RE: Interpretation for PCA/CDPA/FDPA 2002-PR-016-2, Park Crest, Tax Map: 29-3 ((29)):  
Tree Save Area/Limits of Clearing and Grading

**RE: Park Crest Tree Save Area Interpretation  
Plan # 2002 CDPA / FDPA / PCA-PR-016-2  
VIKA #V65719**

TREE SAVE  
 INTERPRETATION  
 EXHIBIT

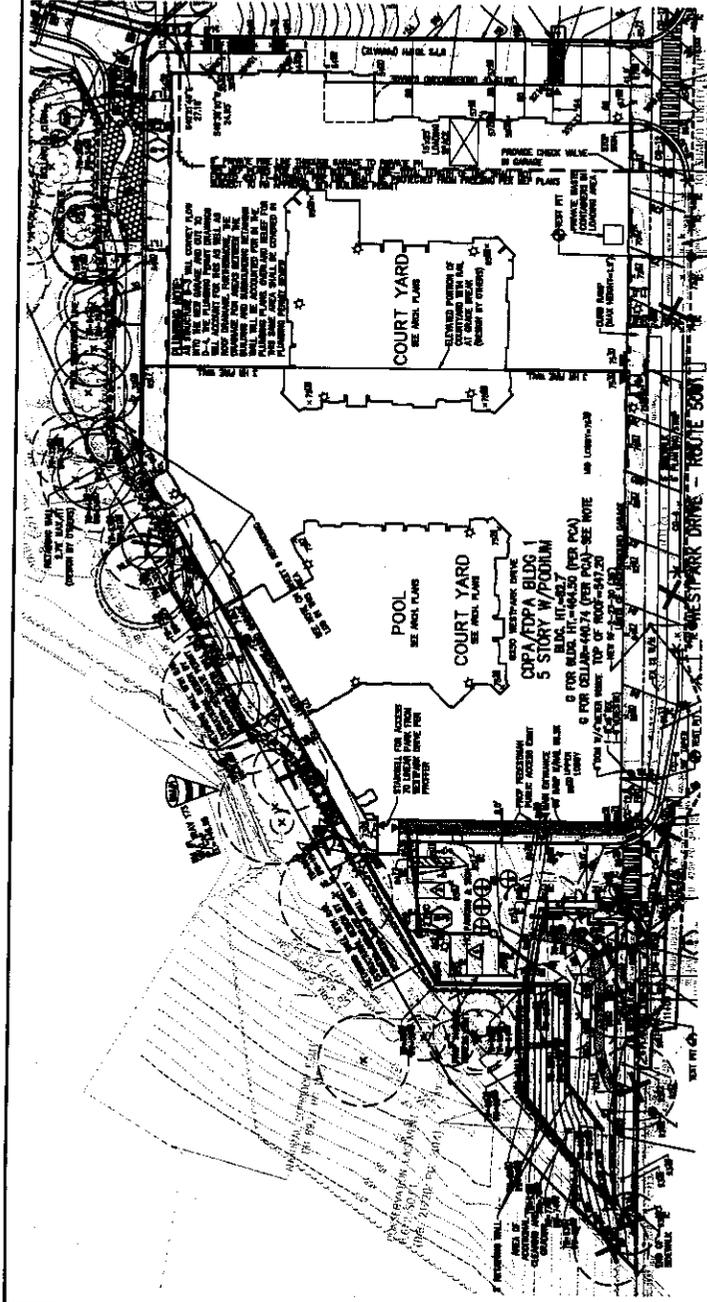
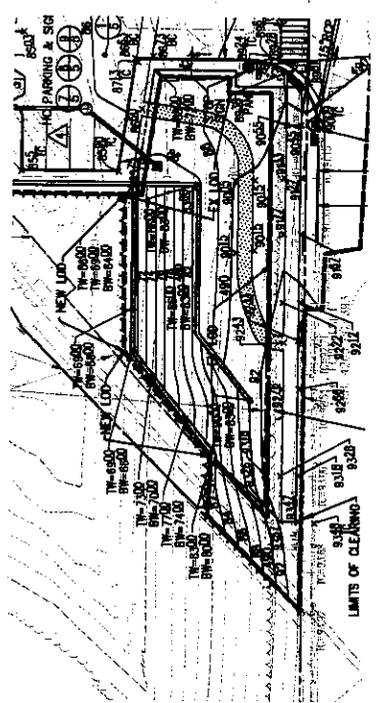
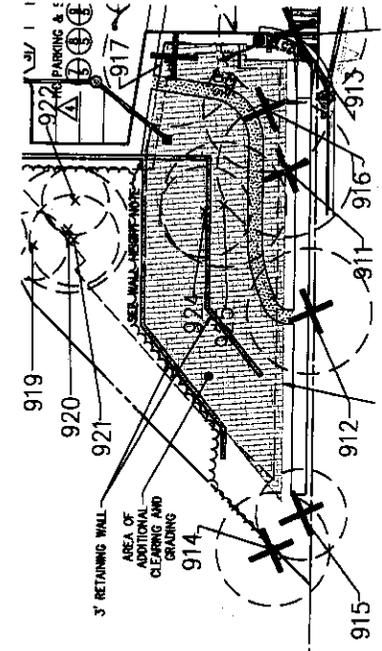
Although the tree save area has been reduced per the revised limits of clearing and grading on the attached sketch, this revision will allow for the installation of a trail from Westpark Drive into the site in this area. Furthermore, these revised limits of clearing and grading will allow for the creation of an open space area which will translate to Westpark Drive and be useable, as opposed to the existing slope which exists in this area at a slope steeper than 3:1. Additionally, as allowed/required by Proffer 8.D, the Applicant will provide a replanting plan for this area to account for the additional tree removal proposed with the revised limits of clearing and grading. Installation of retaining walls as shown on the attached sketch (with heights shown on said sketch) will be required for this revised open space area.

**WALL HEIGHT NOTE:**  
 AT THIS CORNER WALL HEIGHT WILL EXCEED 3', BUT WILL REMAIN UNCHANGED FROM APPROXIMATE HEIGHT - WALL HEIGHT WILL REDUCE MOVING IN A WESTERLY AND SOUTHERLY DIRECTION TO 3' IN HEIGHT

**NOTE:**  
 TREES 911, 912, 913, 914, 915, 916, AND 917 WERE PREVIOUSLY SCHEDULED TO BE REMOVED, AND ARE STILL TO BE REMOVED. TREES 919, 920, 921, AND 922 WERE SCHEDULED TO BE PRESERVED AND WILL STILL BE PRESERVED. TREES 924 AND 925 WERE PREVIOUSLY SCHEDULED TO BE PRESERVED BUT ARE NOW TO BE REMOVED. REFORESTATION PER APPROVED PROFFERS SHALL APPLY TO THIS NEW TREE REMOVAL.

It is my determination that the proposed modifications to the tree save area located to the west of Building 1 as described above, are in substantial conformance with proffers and the CDPA/FDPA, subject to final approval by DPWES, and provided that a replanting plan is submitted and implemented as determined by UFM, DPWES. This determination addresses only the issue discussed herein and has been made in my capacity as the duly authorized agent of the Zoning Administrator.
